Date: 9/11/2023

TO: DRB

FROM: Janet Showers Patterson

RE: Gunther Boathouse Application

#### Computing the Slope:

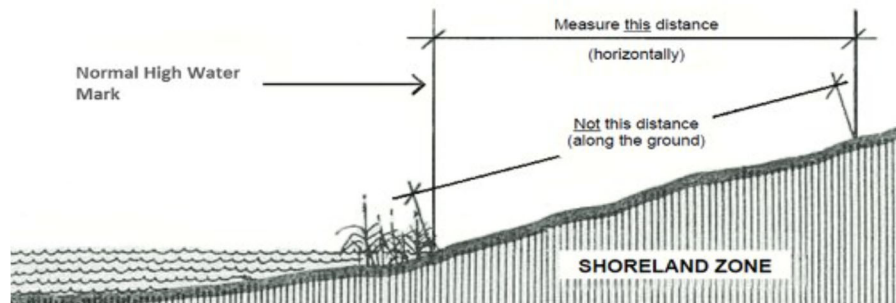
- “Run” must be measured in a horizontal plane and not along the ground surface, as is depicted in the below figure from the Shoreland Protection Act Handbook. Measuring run along the ground surface produces a larger distance than measuring horizontally and would produce a smaller slope than if computed correctly using the horizontal run.

- The horizontal run must be computed perpendicular to the slope; that is, perpendicular to the elevation contours (which are lines of constant elevation). Source: Shoreland Protection Act Handbook, Appendix B. Water will flow or a ball will roll down the steepest path on the hill and that path is perpendicular to the contour lines; this is the difference between trails going straight down the mountain versus having switchbacks along which the slope is gentler. Once again, using a measurement of run that is not perpendicular to the contour lines will estimate a larger run and will bias the slope lower.

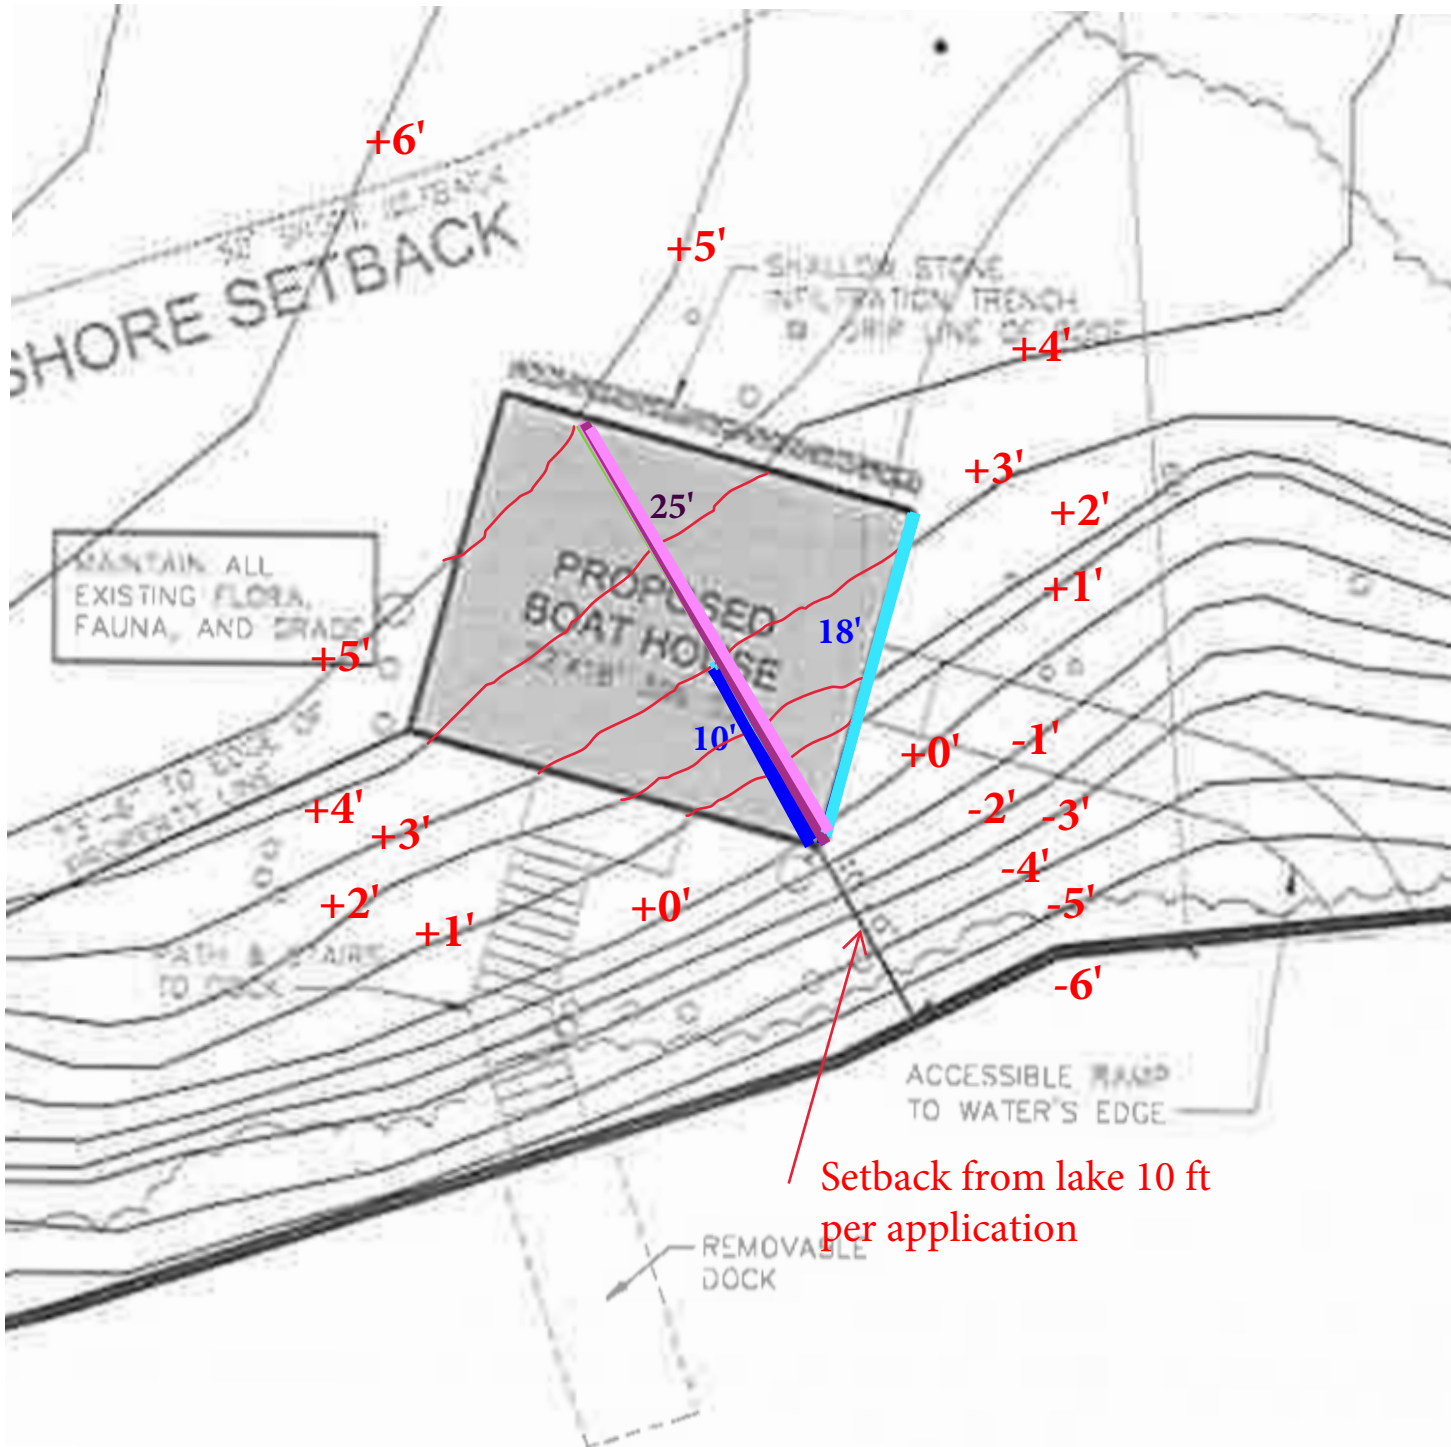
I measured slope from the applicant’s site plans which include elevation contour lines (I believe them to be spaced 1’ apart and have verified that is consistent with elevation data available online on the VT Natural Resources Atlas). Calculating slope based on contour lines and maps is one of the methods which is suggested by the state. See the attached enlargement of the applicant’s boathouse site plan:

- In the attachment, I have labeled each of the elevation contours by the vertical distance relative to the southeast corner of the proposed building which is located 10 feet from the lake.
- The northeast corner of the proposed building is +3’ higher than the southeast corner.
- The eastern edge of the footprint is 18’. However, to use that distance as the “run” in computing slope is incorrect because that building edge does not run perpendicular to the elevation contours. The distance between the southeast corner and the +3’ elevation contour is only 10’

when measured perpendicularly to the contour lines. Thus, done correctly, slope =  $3'/10' = 30\%$ .  
Conclusion: the slope of the proposed site closest to the lake is double the allowable 15%

- This analysis can be extended to include the slope of the entire BH site. In this case, the contour lines show a +5' difference in height (not a 3' difference). The perpendicular run is approximately 25'. Slope =  $5'/25' = 20\%$  which is still higher than the allowable 15%.

This analysis suggests that the slope of the project side is >15% and not in compliance with the bylaw. This could be rectified by moving the proposed site plan away from the lake where the ground is more level.

**Dark Blue Line:**  
 Rise = 3'  
 Run correctly measured perpendicular to contour lines = 10'.  
 Slope =  $3'/10' = \underline{30\%}$

**Aqua Line :**  
 Rise = 3'  
 Run incorrectly measured along east end of footprint = 18'.  
 $3'/18' = \underline{16.7\%}$

**Pink Line:**  
 Rise = 5'  
 Run = 25'  
 perpendicular to contour lines  
 Slope =  $5'/25' = 20\%$
